## Questions and Answers

### For OG&E's 2022 Flexible Resource RFP

#### Question #34

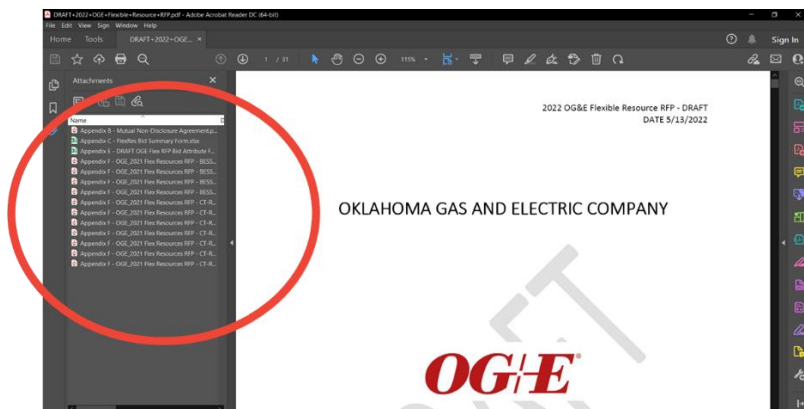
This particular sentence in the recitals, "WHEREAS, each Recipient is willing to receive disclosure of the Confidential Information pursuant to the terms of this Agreement for the purpose of \_\_\_\_\_." – what description would OG&E like us to insert? (e.g., evaluating our project offerings or exploring OG&E resource needs or something else)

**A:** OG&E suggests this description: "WHEREAS, each Recipient is willing to receive disclosure of the Confidential Information pursuant to the terms of this Agreement for the purpose of submitting a Bid(s) including the documentation and data requested in the RFP which may contain Bidder or Company commercially sensitive information."
